# Push to Talk Mic Panel Modification to Push to Mute

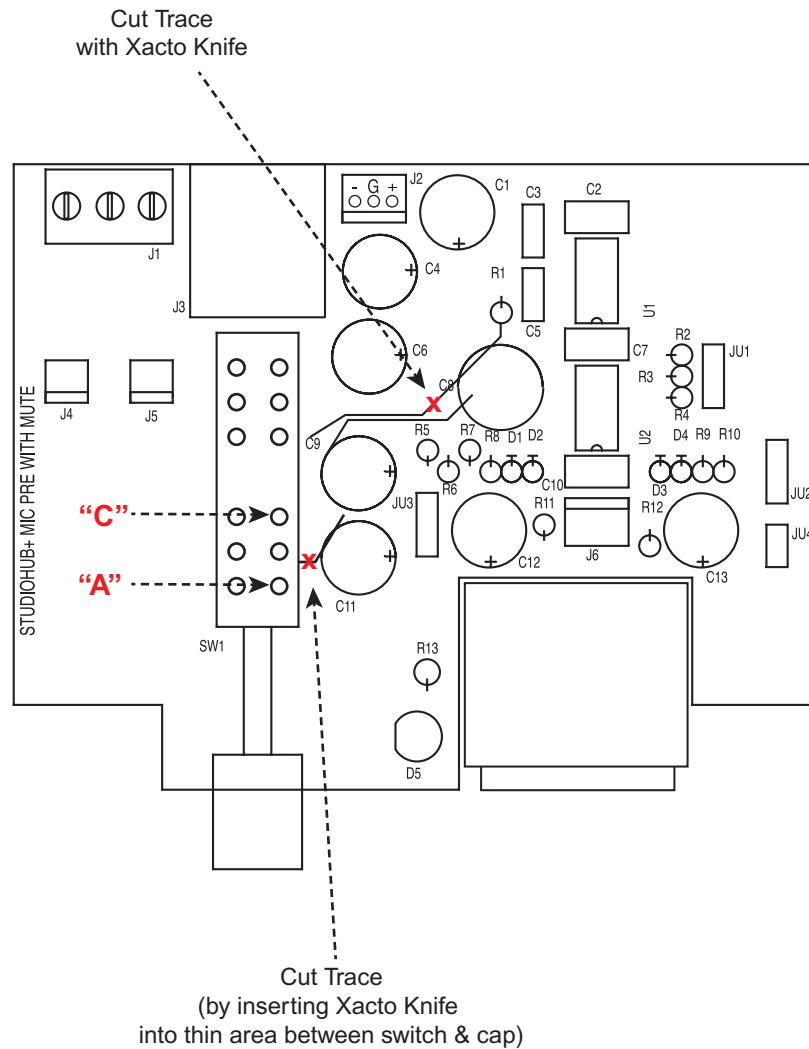
1. Cut 2 traces as shown
2. On solder side, install a jumper from the body of R1 to switch position “A”
3. On solder side, install a jumper from the body of R6 to switch position “C”
